Limited Visual Dam Safety Inspections

OA00045

Helemano 16 Reservoir

May 2006

View of spillway looking upstream; notice erosion where lining ends

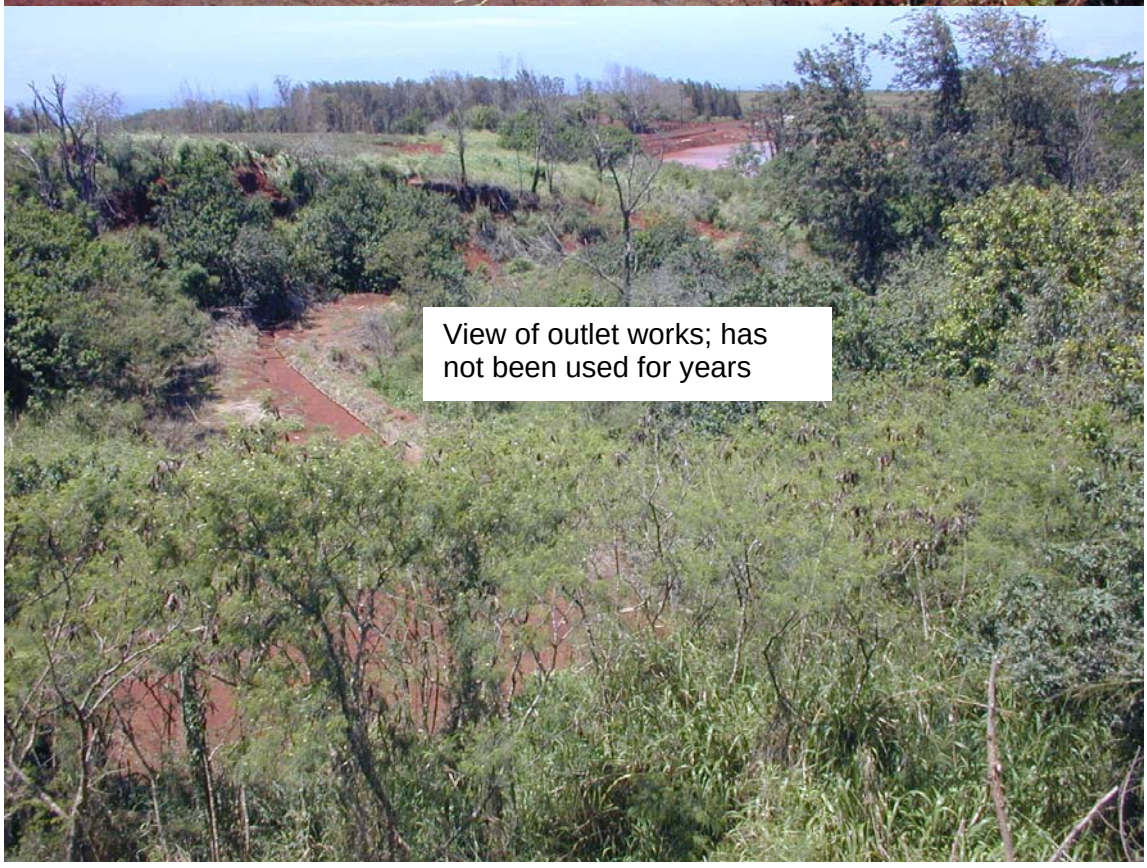
b. Slope protection needs maintenance or repair. Description: Provide protection against erosion observed.
c. The spillway approach was partially blocked with vegetation. Clear approach.
d. Severe scour erosion was observed which requires maintenance and/or repair. Description: Erosion observed at downstream end of the lined spillway.
e. Unclear if spillway is adequately sized. Spillway should pass the probable maximum flood. Verify spillway capacity and take corrective action as required.
